## THE COLONG FOUNDATION FOR WILDERNESS LTD.

### **Re: Springvale Water Transfer and Treatment Project SSD 16\_7592**

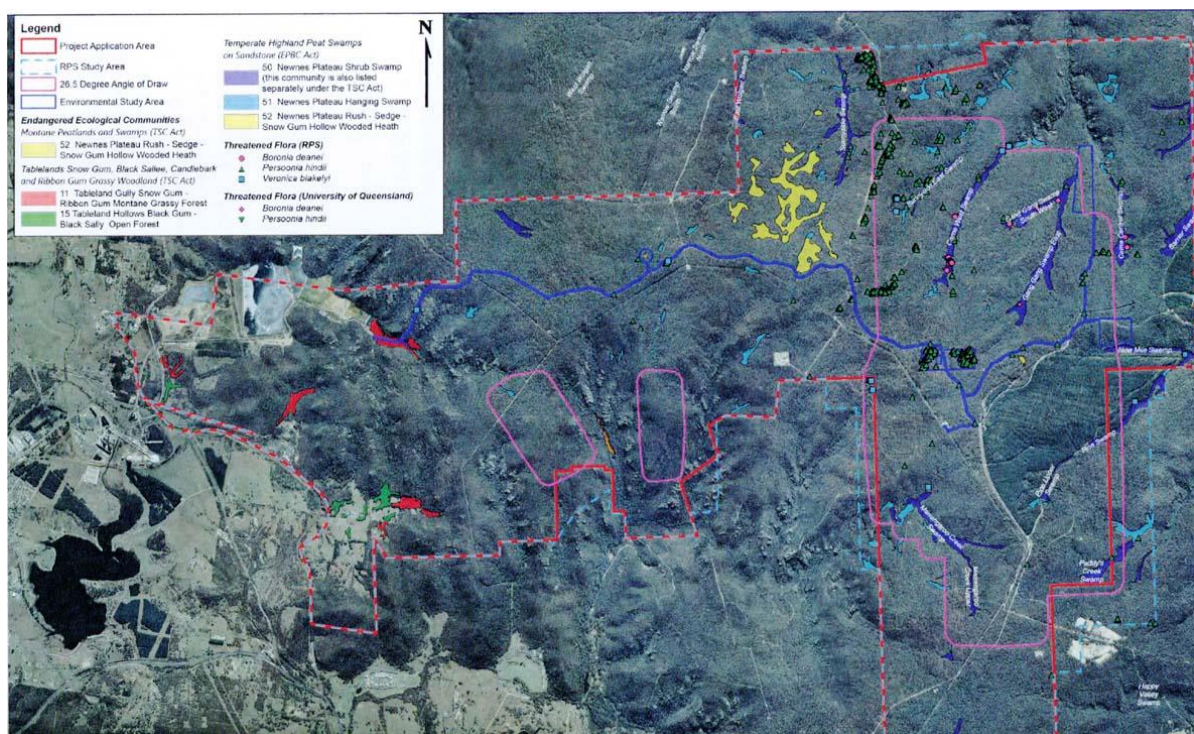
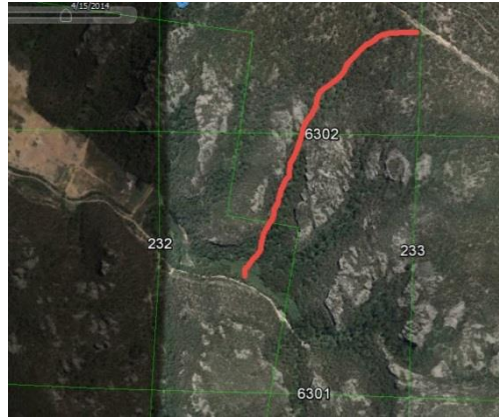
Existing transfer pipeline enters Sawyers Swamp Creek valley from the west (figure above), the proposed pipeline would enter this valley from the north causing unnecessary environmental disturbance (figure below from the 2014 Springvale Mine extension EIS).

1. The existing pipeline easement from the balance tank on Newnes Plateau to LDP009 should be used by any future pipeline.
2. The operator of Mt Piper Power Plant must store all surplus mine water in its storages.

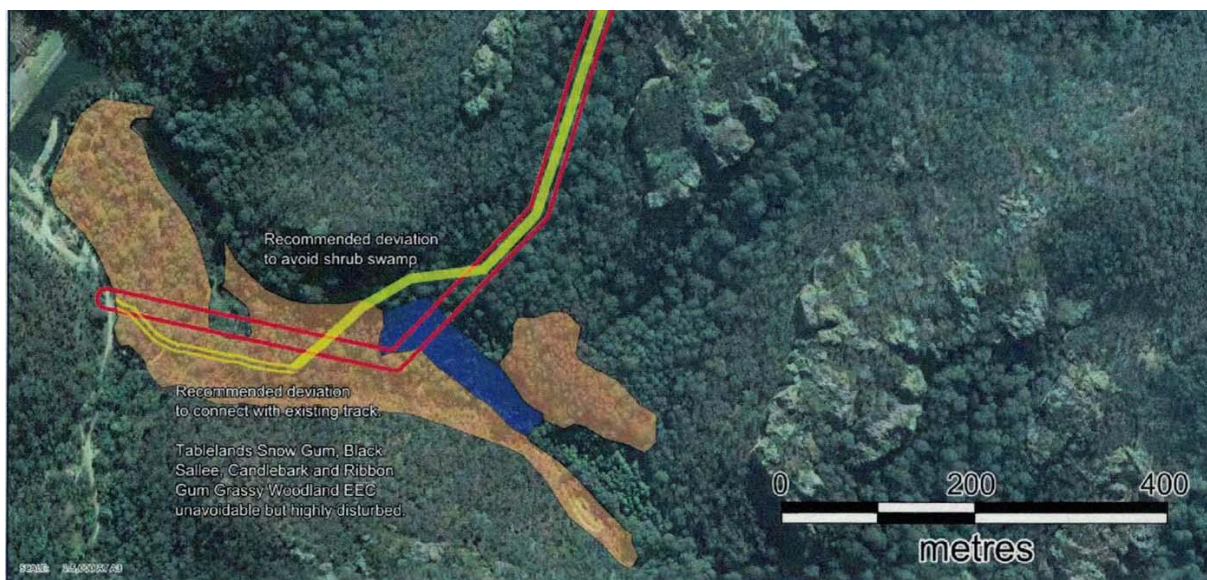
*Proposed pipeline and road route descends through a gully that lies between Clerestory Spurs 7 and 8 and then proposes to clear MU11, an endangered ecological community. How can this be less damaging than following the existing pipeline easement, and what are the justifications for pipeline relocation? (figure below from the 2014 Springvale Mine extension EIS).*

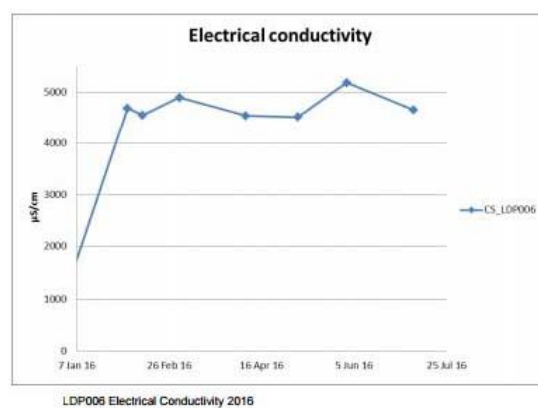
It is clear that the EIS does not implement the intent of condition 4 by storing mine water in Thompsons Creek reservoir, just as the EIS does not clearly state the main benefit of the project.

Thompsons Creek reservoir should be used to store all treated mine water and achieve compliance with condition 4 of the power plant's water licence. The current proposal is in breach of the power plant's water licence and should not be approved until this is fault remedied.

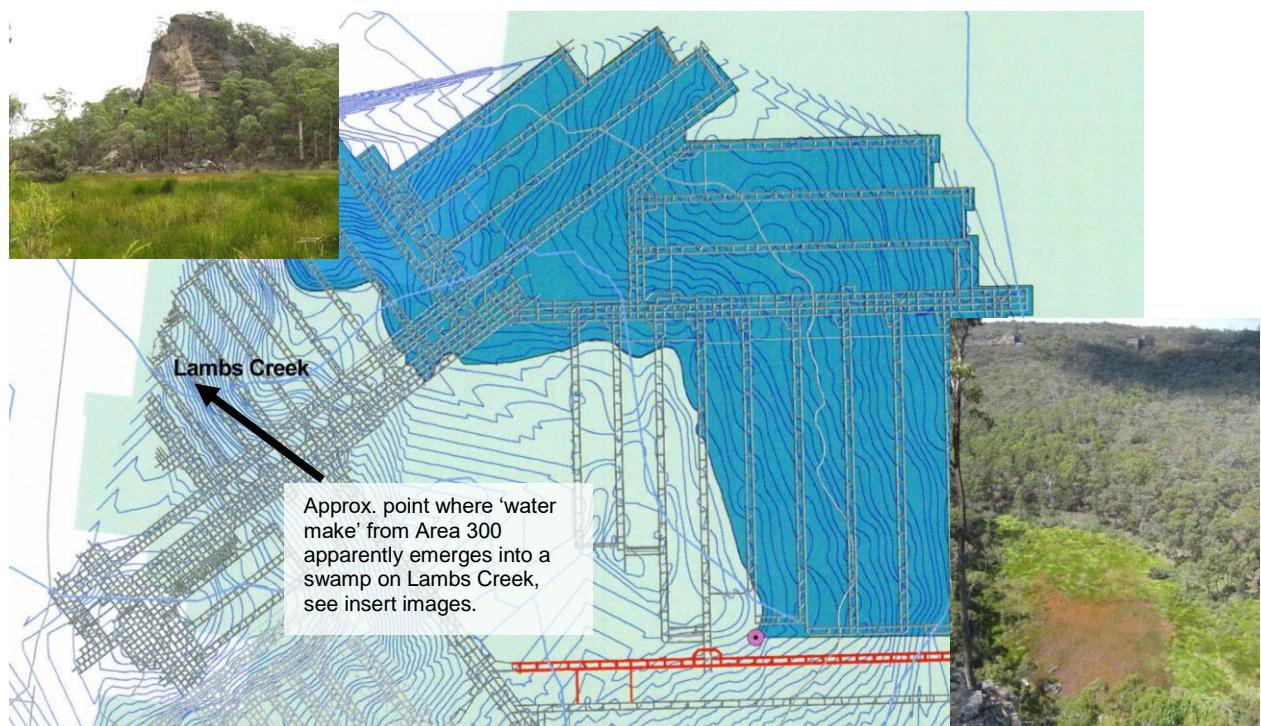
*The figure and inset images above indicate the arrangement of Angus Place underground storage and a very*

*green, iron stained swamp that lies above it. Swamps that receive mine effluent, such as those at the Baal Bone Colliery have a similar appearance.*

The Colong Foundation opposes use of this underground storage as part of the Springvale Water Treatment project. The spring that surfaces at Lambs Creek is suspect and probably contaminated

9. Mine water must not be stored in Angus Place mine as part of the Springvale Water Treatment Project.
